Contractor:	Tradition Construction Inc.	Date:	October 1, 2024
Reason for Change:	Owner Request	Project Name:	Coldstream Municipal Office Addition and Renovation
		Project No.:	RFT-CMS-2023-01; +VG #22281

1. To remove existing wall tile and patch & repair walls as required to receive new finishes as per enclosed drawing AR-47 & AR-52. Provide laminated gypsum board & tile backer board at existing block walls as per enclosed drawing AR-47.

CONTEMPLATED CHANGE ORDER

1.1 CCO-ME-14 Washrooms 168 & 169 Refresh

1 GROUND FLOOR PLAN - HVAC NEW
M4.0 SCALE: 1:100

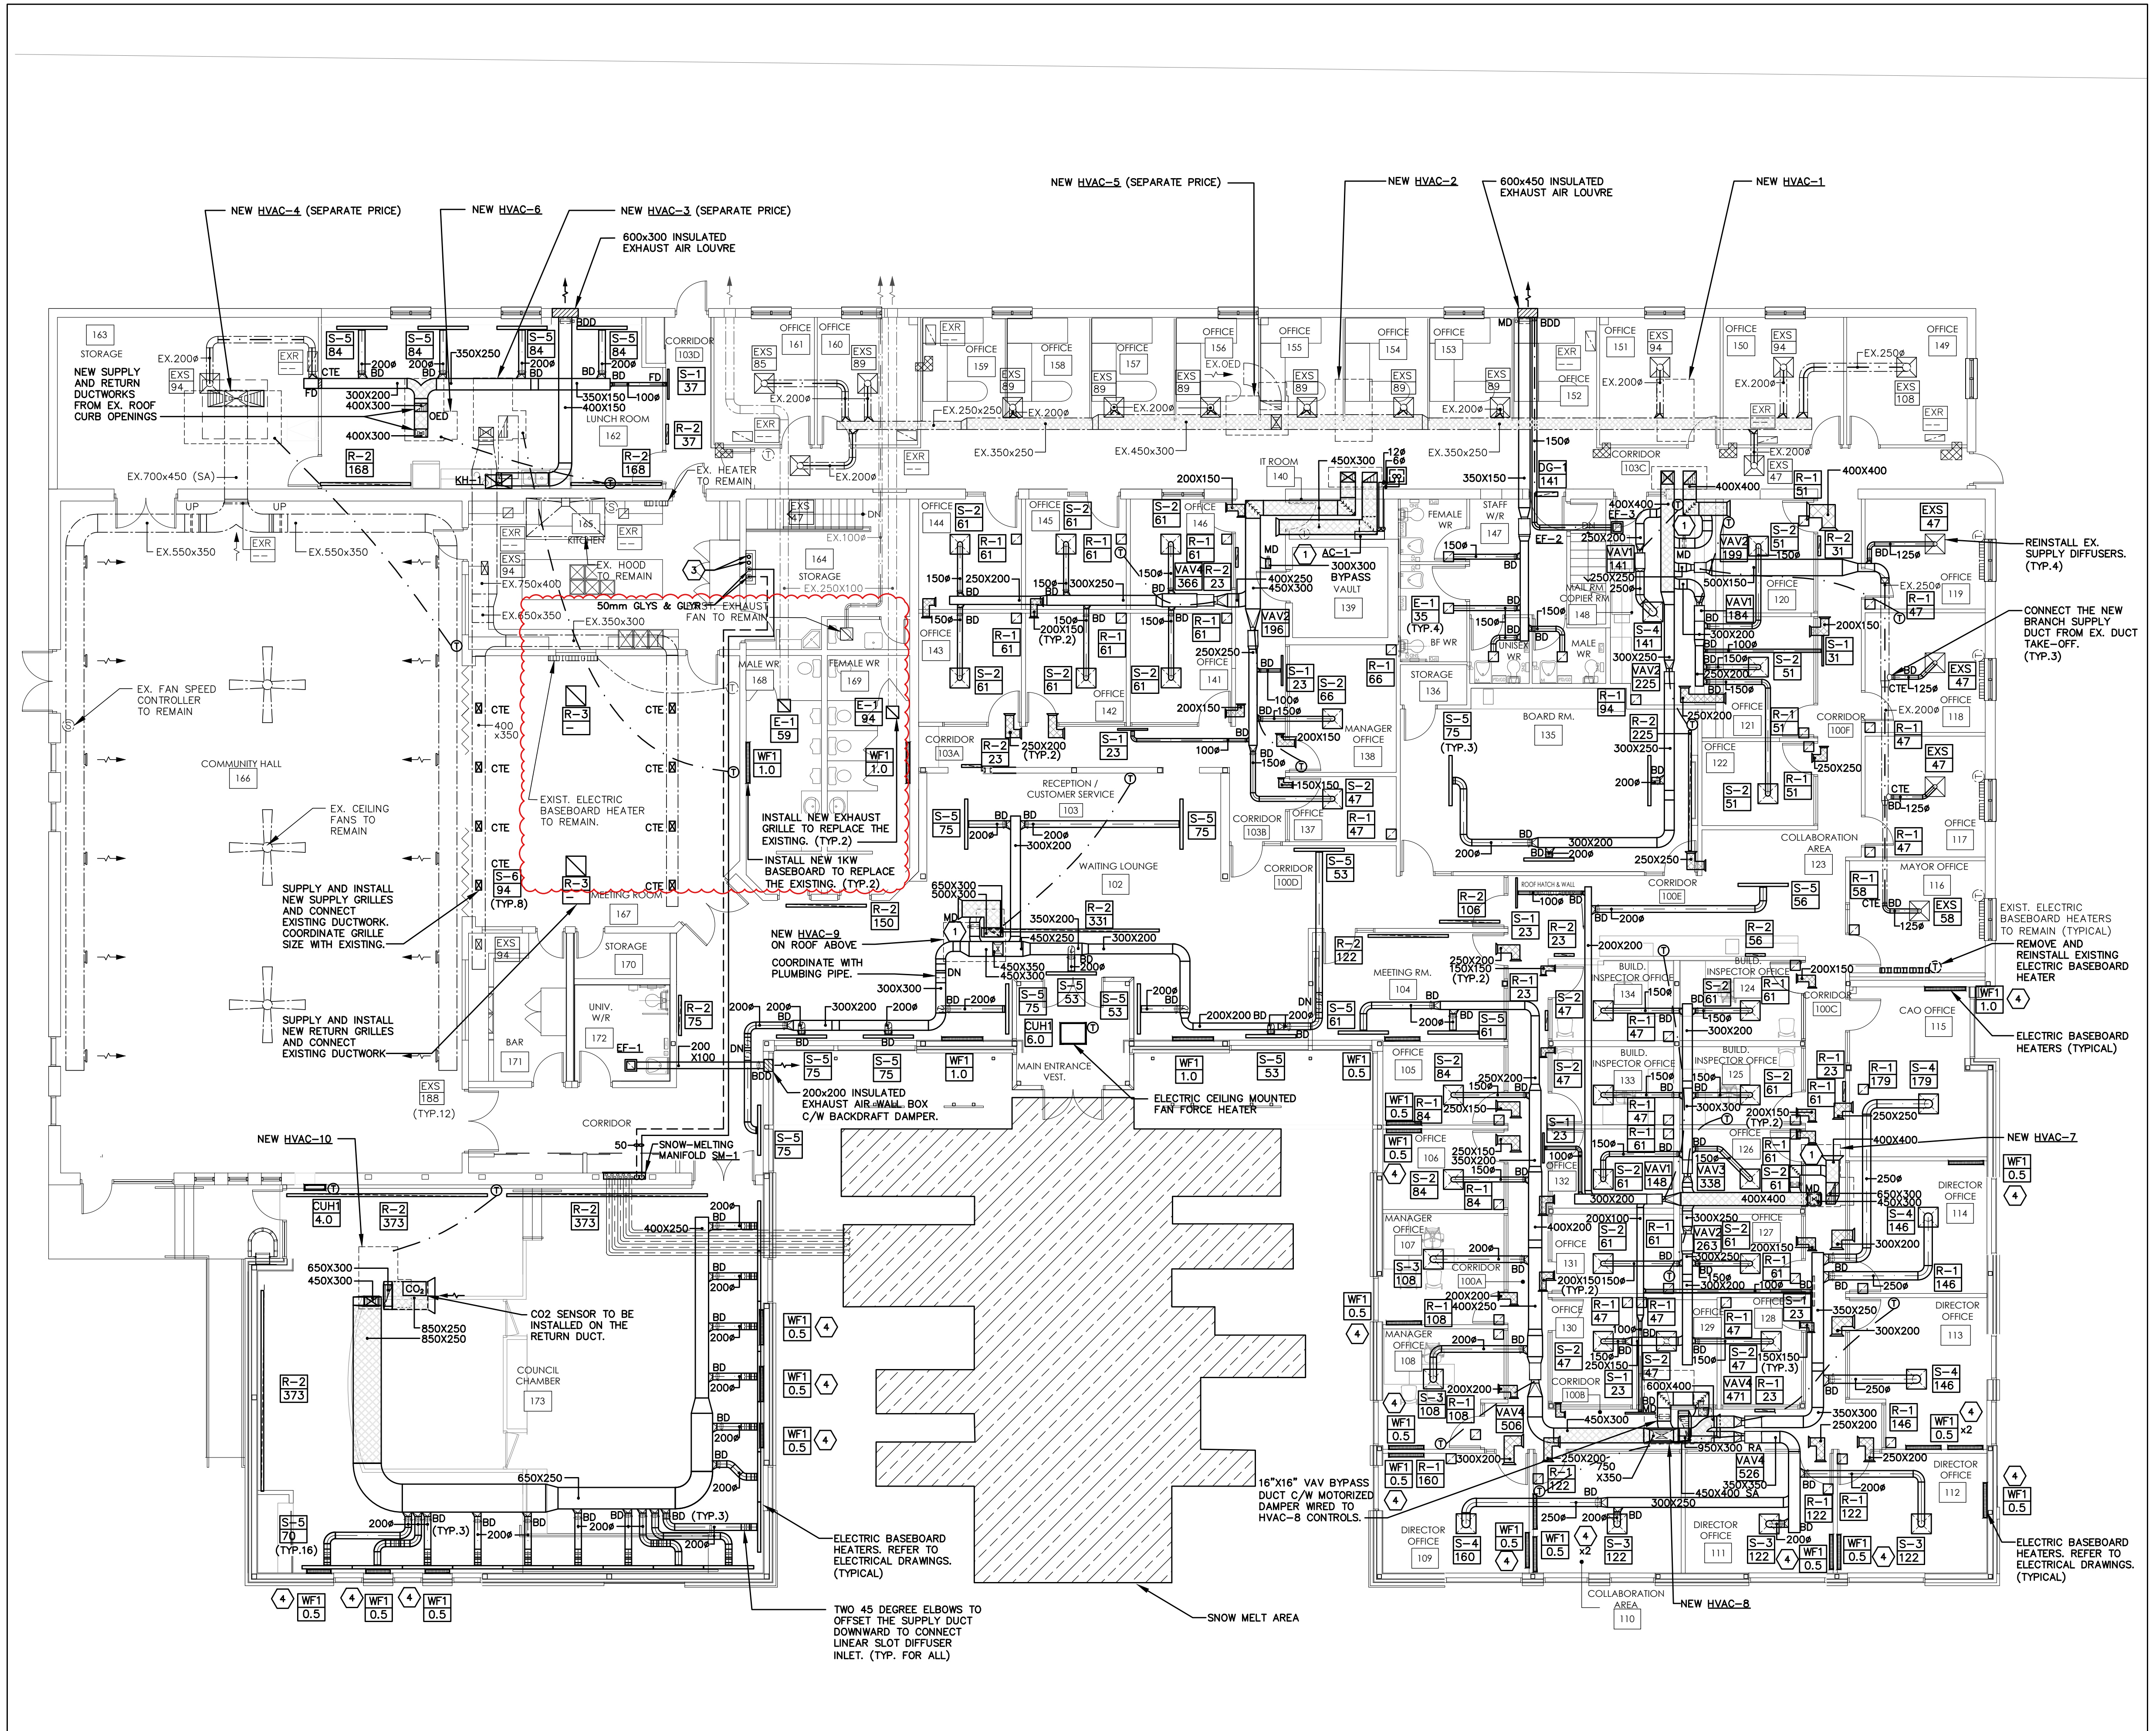
- .3 Remove the existing electrical baseboard in the 168 WR and 169 WR.
- 3.4 Refer to Drawing *M4.0 Ground Floor Plan – HVAC New*
- .1 Refer to revised drawing M4.0.7 included herewith.

- .2 Add new exhaust grille of the existing exhaust fan in the 168 WR and 169 WR.
 - .3 Add new electrical baseboard in the 168 WR and 169 WR.

1 GROUND FLOOR PLAN - LIGHTING
E2.1 SCALE: 1:100

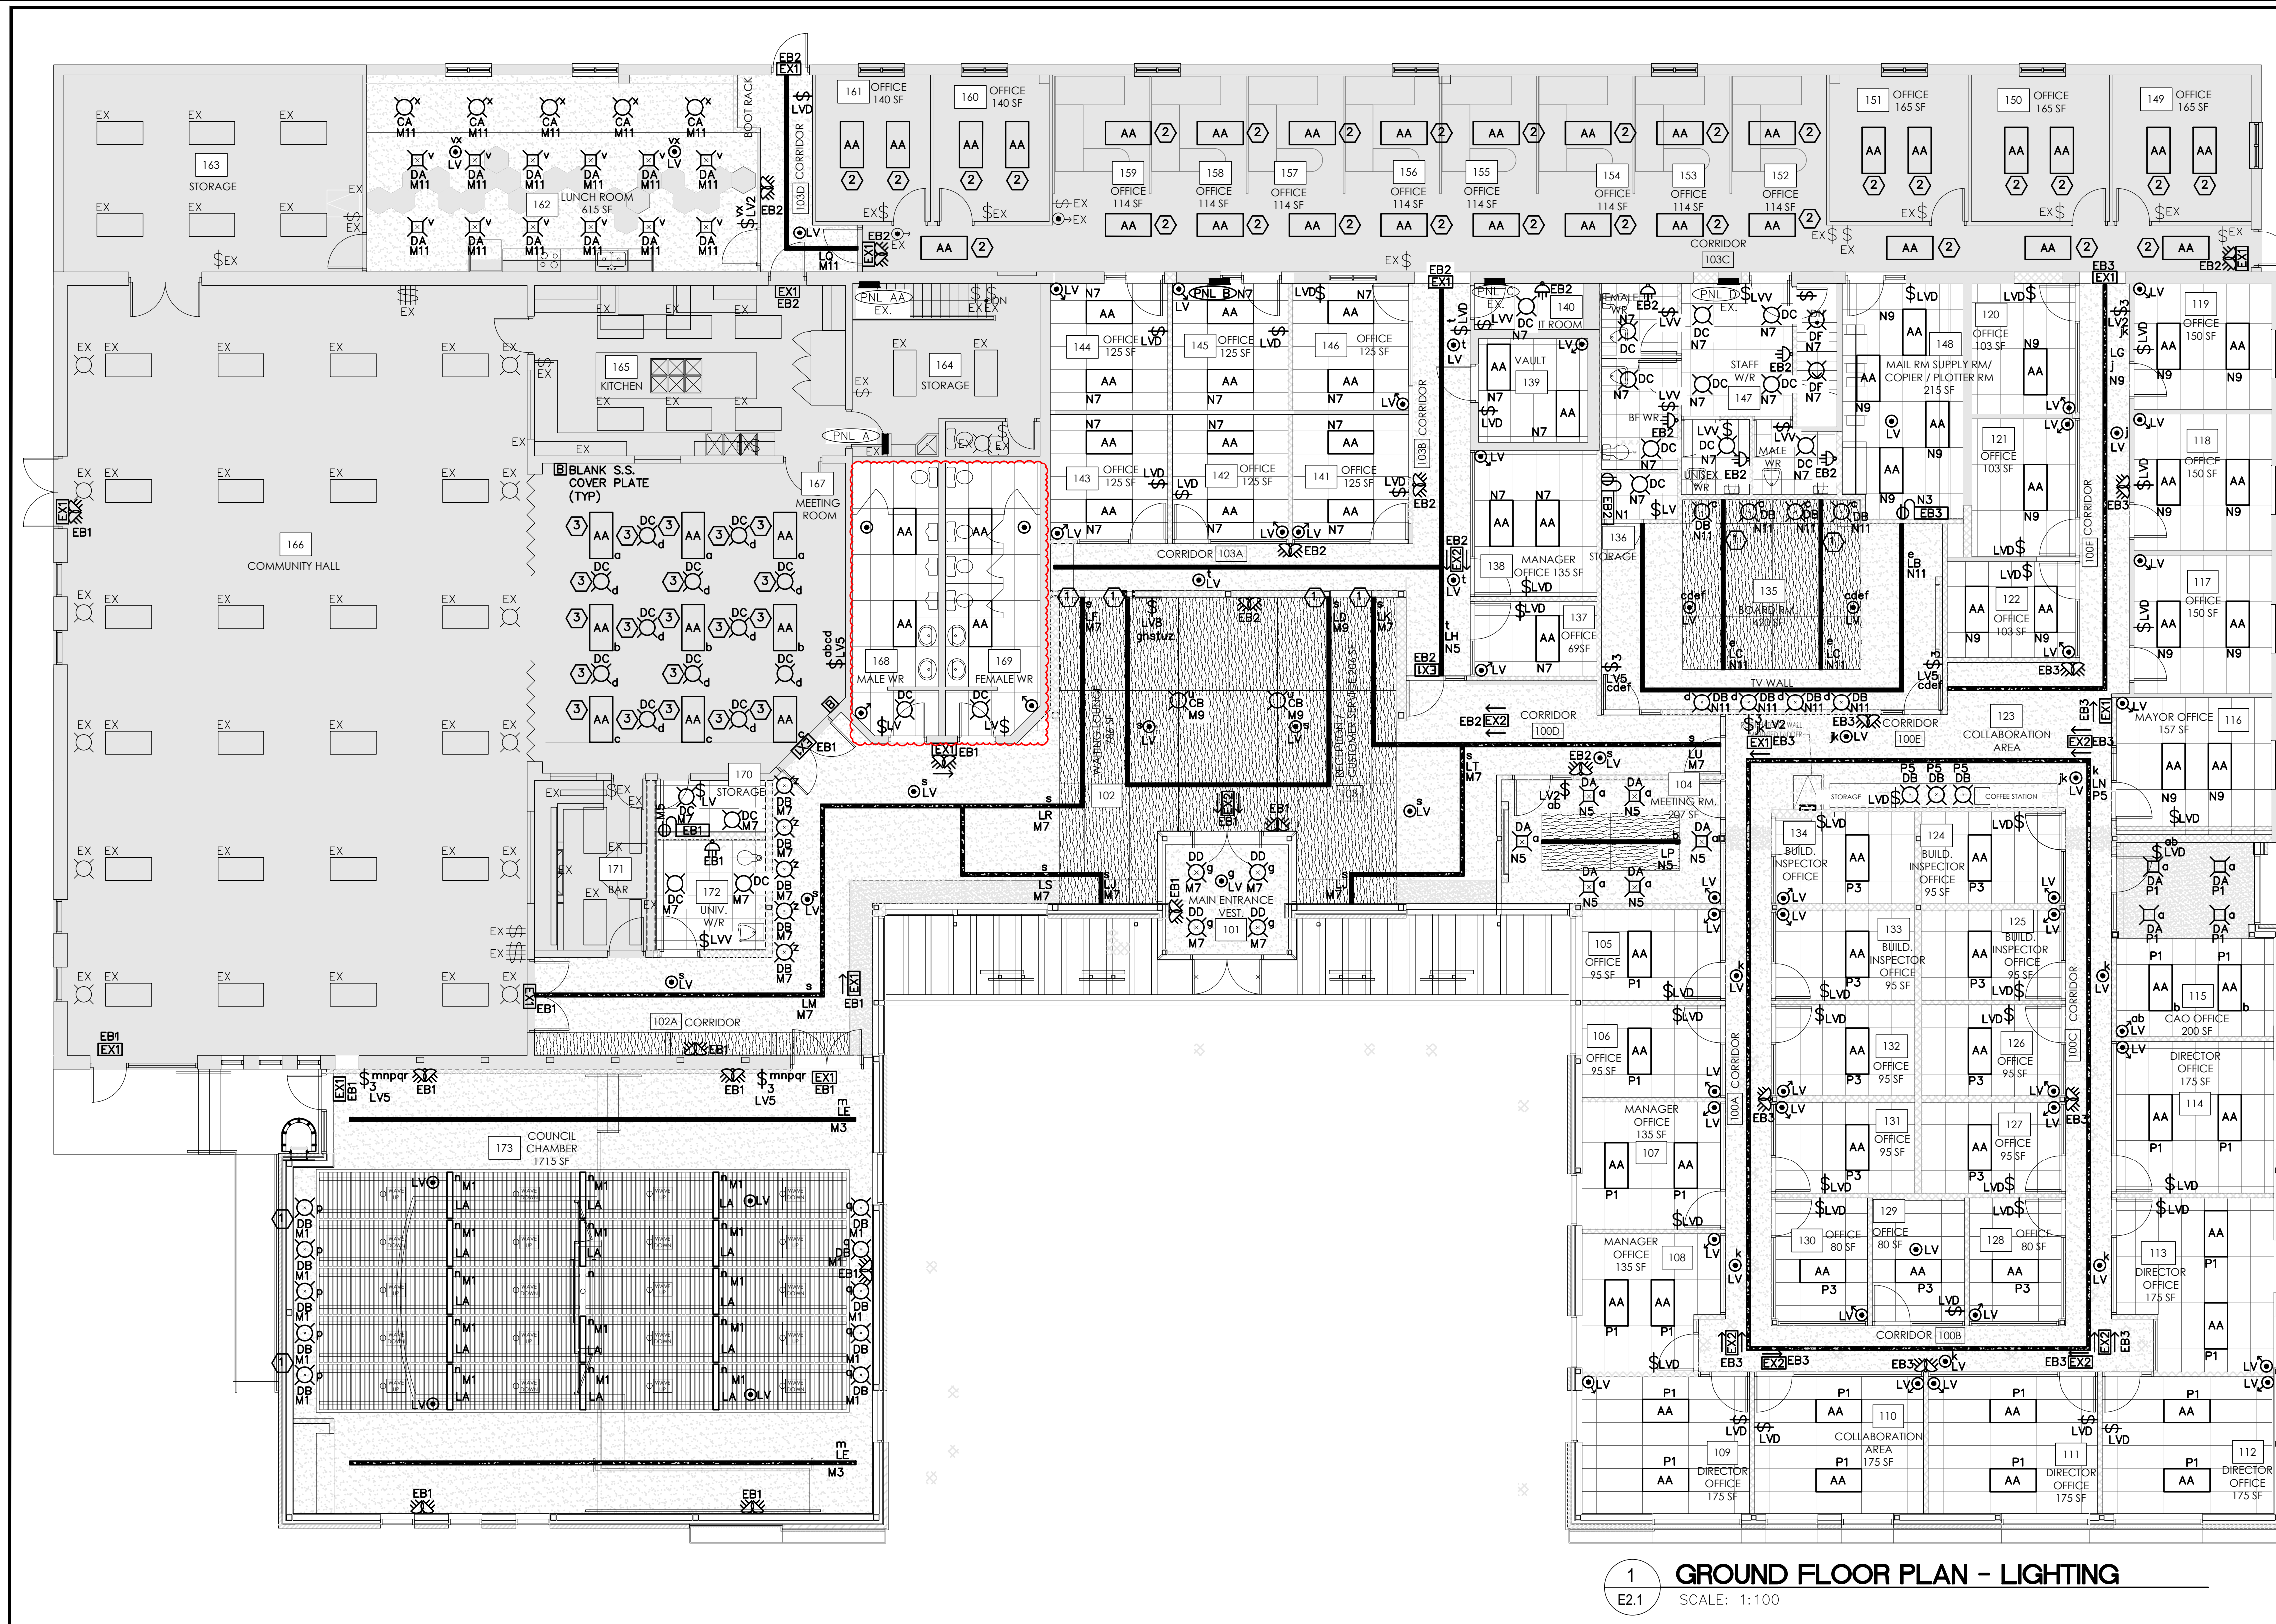
- 3.6 Refer to Drawing E2.1 Ground Floor Plan – Lighting
 - .1 Refer to revised drawing E2.1.7 included herewith.
 - .2 Add new light fixtures and associated light switches and occupancy sensors.

1 GROUND FLOOR PLAN - POWER AND SYSTEMS
SCALE: 1:100

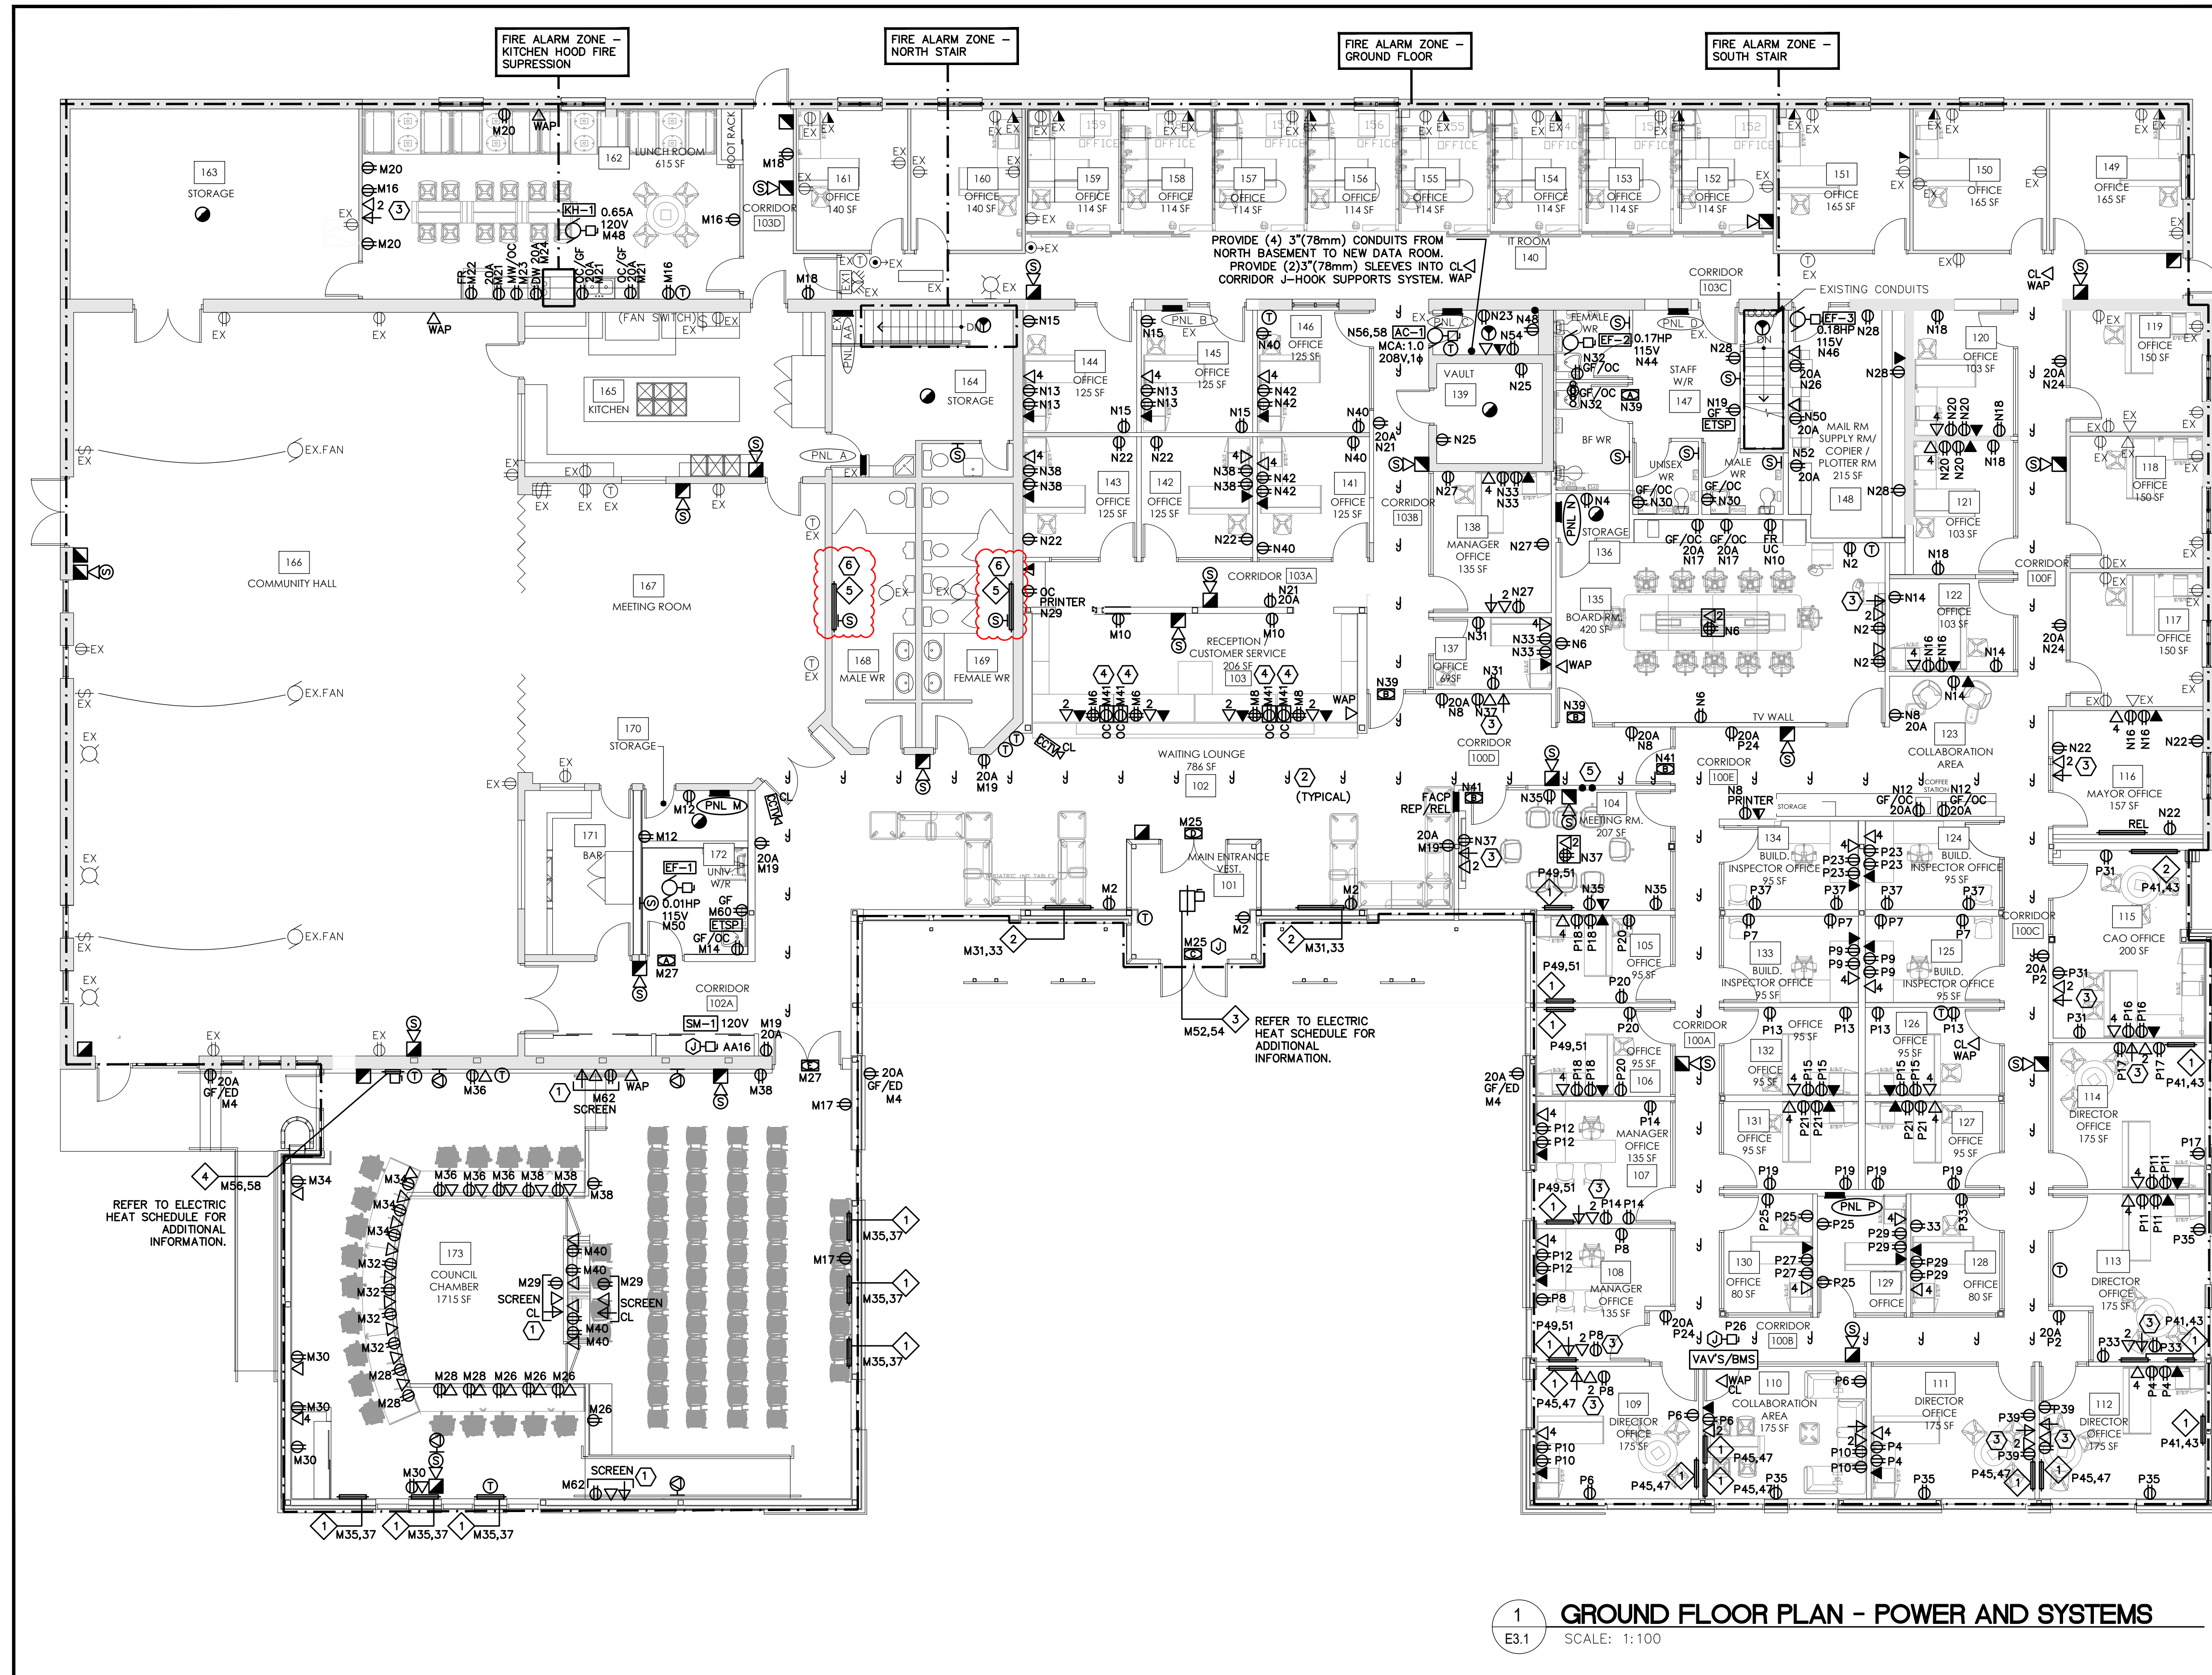
- 3.7 Refer to Drawing E2.1 Ground Floor Plan – Lighting
 - .1 Refer to revised drawing E3.1.4 included herewith.
 - .2 Add new baseboard heaters.
 - .3 Revise electric heat schedule.
